EXAMPLE #1

For projects less than one acre and no new connections to the City/County storm sewers

UNIVERSITY OF MICHIGAN
WILLIAM L. CLEMENTS LIBRARY INFRASTRUCTURE
IMPROVEMENTS AND ADDITION
UM PROJECT NUMBER: P00001692
RIGHT OF WAY GRADING PLAN

ATHLETIC DEPARTMENT OPERATIONS CENTER

SCALE
HORIZ. 1"=20'
VERT. 1"=2'
DRAWING NO. CG1.1
SHEET NO. OF

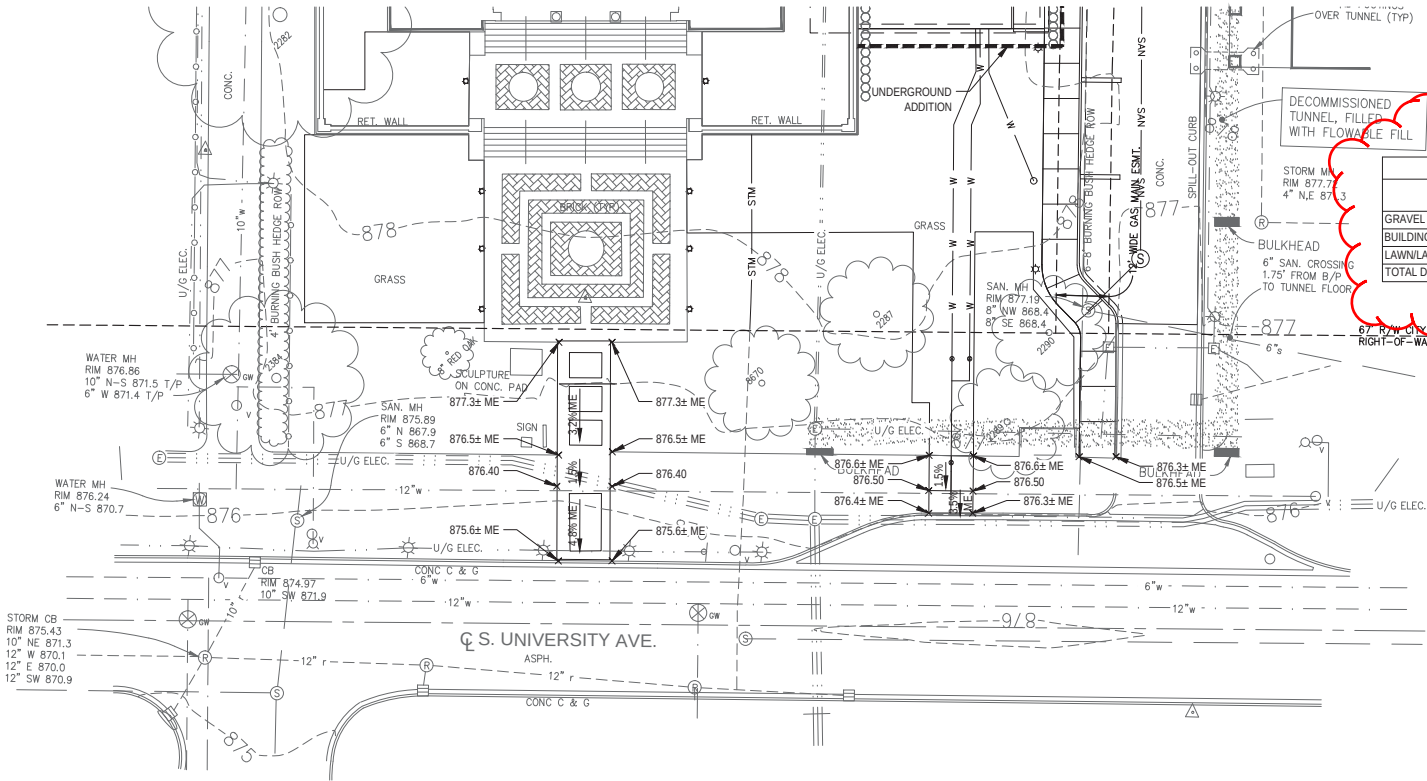
Show chart of with change in impervious -see attached example chart. Increase in impervious must be reviewed/approved by U-M Campus Planning and project team may be directed to design additional storm water management BMPs.

Provide a list of elective storm water BMP's to be installed and quantify benefits, if feasible.

Include the language: "Construction and operation of the storm water (infiltration/detention pond) or (BMP's on the plans) is/are in compliance with the requirements of State and Federal water pollution control laws."

Replace chart with format matching example chart below

C104C

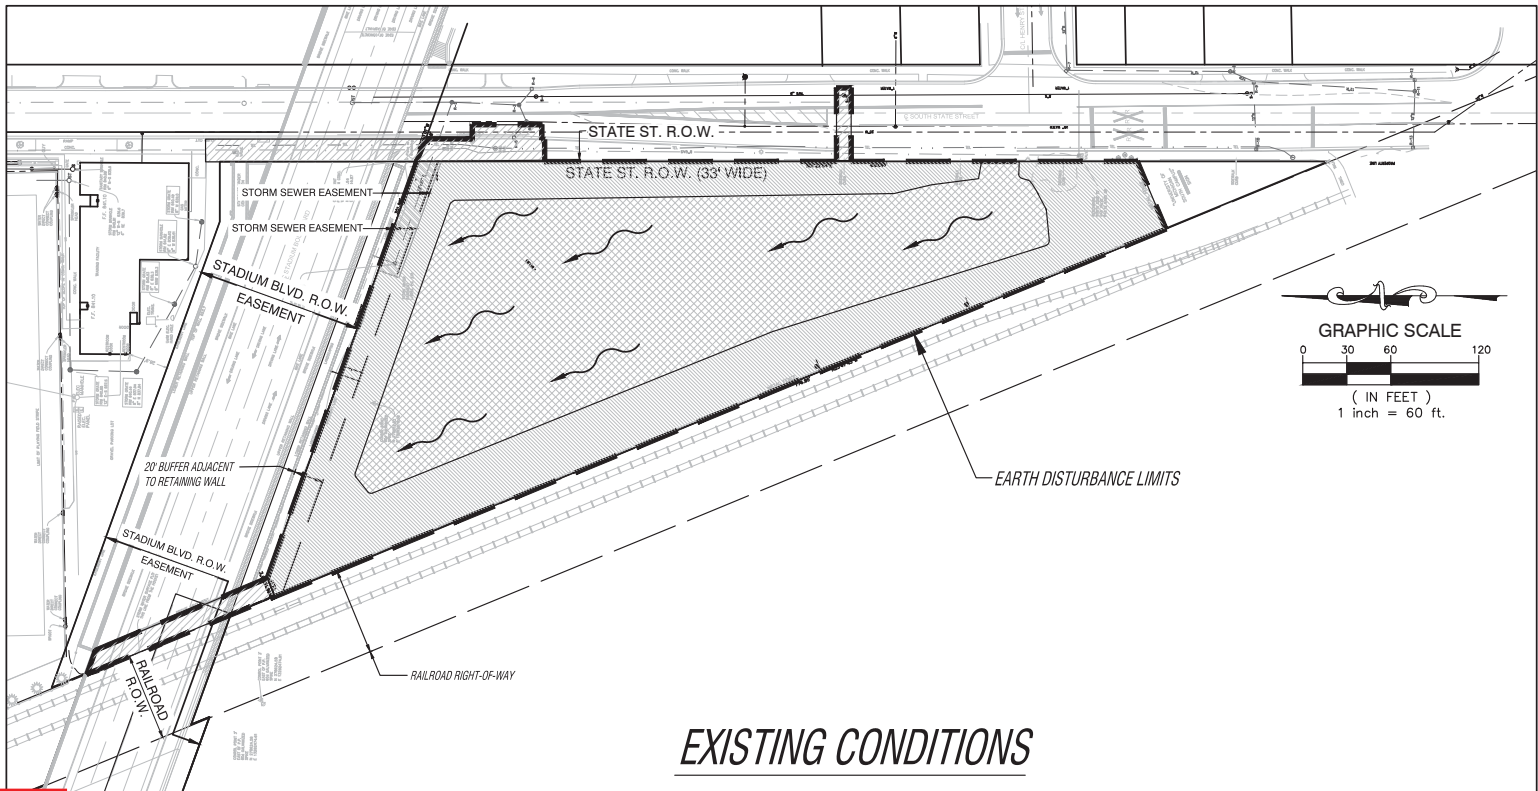
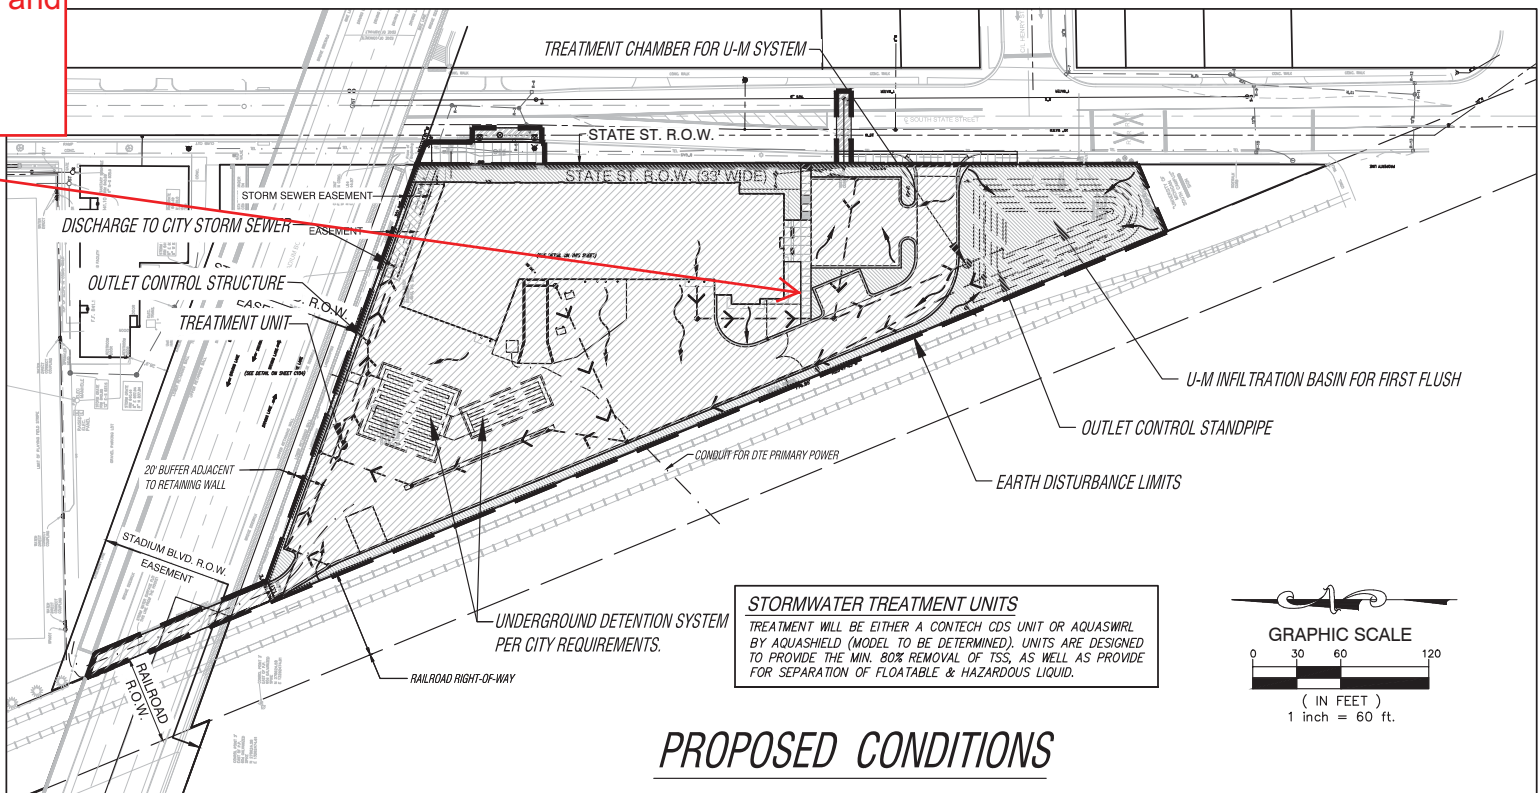
- Storm water sheet.
- Show drainage patterns of proposed and existing conditions with different hatching based on imperviousness. (See Campus Planning level of detail provided on U-M property)
- Provide narrative summarizing storm water as noted below.

Storm water narrative

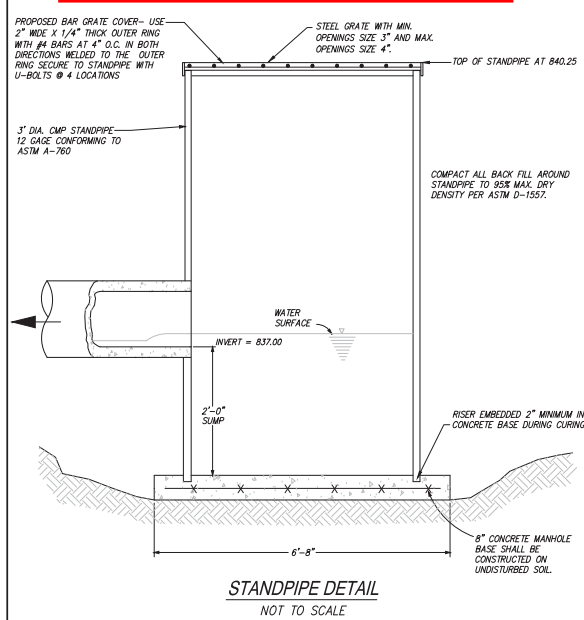
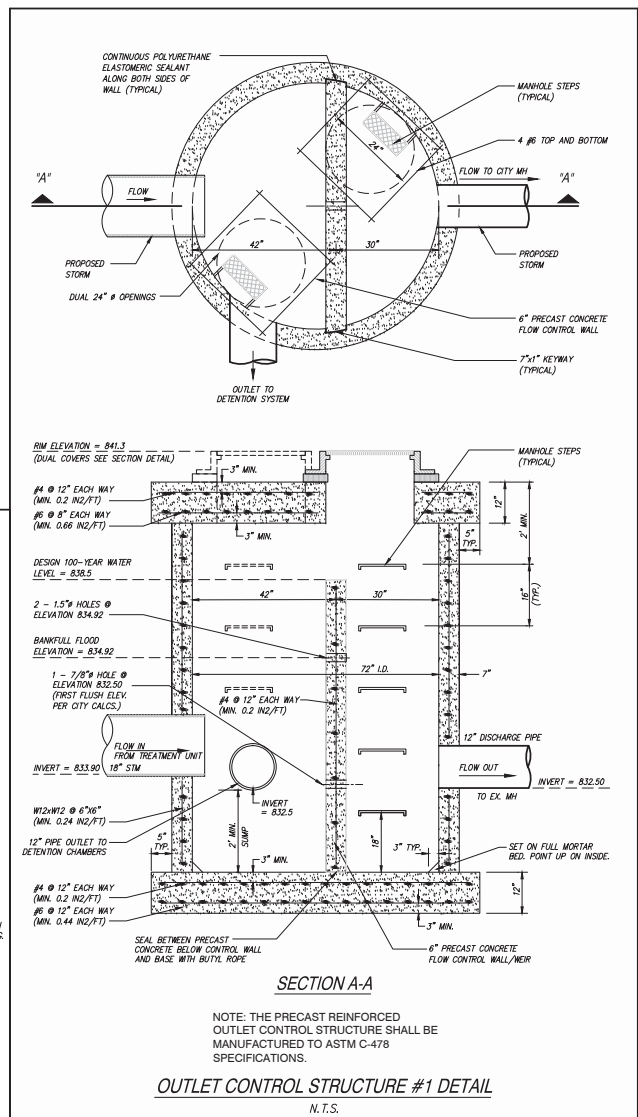
Provide sheet with storm water management plan.

Include details for storm water management structures.
